Appendix F: Support Documentation Change Reports for the Guidance and Control Software Project

This document was produced as part of Guidance and Control Software (GCS) Project conducted at NASA Langley Research Center. Although some of the requirements for the Guidance and Control Software application were derived from the NASA Viking Mission to Mars, this document does not contain data from an actual NASA mission.

Support Documentation Change Report

a. Report #: 2.2-27

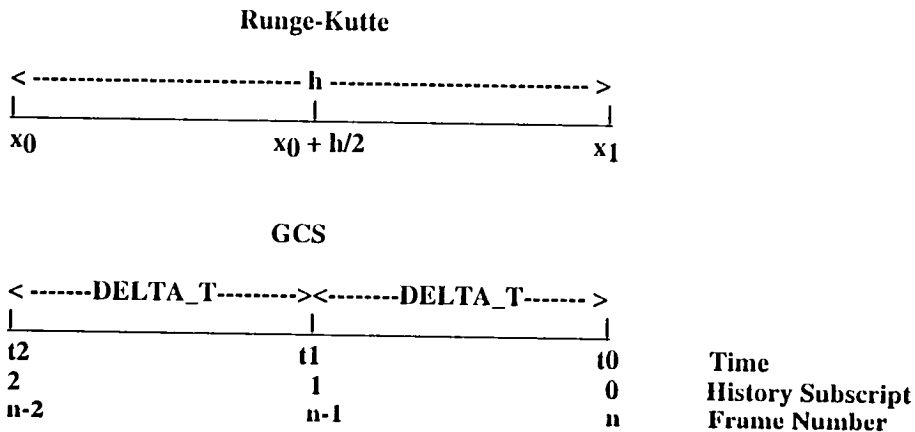
The GCS problem to be solved is as follows:
